Energy Code review comments only. bldg/zoning comments issued separately.

Energy code review comments 2-20-15

MANHATTAN WEST NEW YORK , NEW YORK

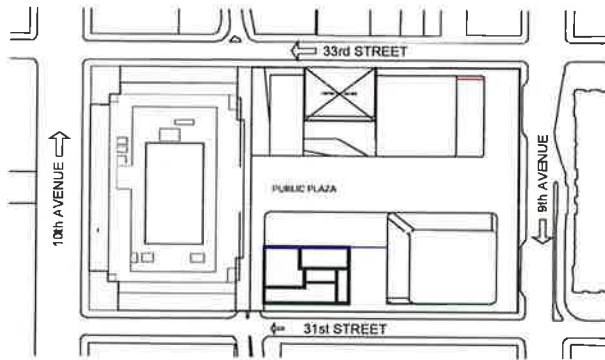
- ✓ Provide support documentation for energy savings for Interior and Exterior lighting.
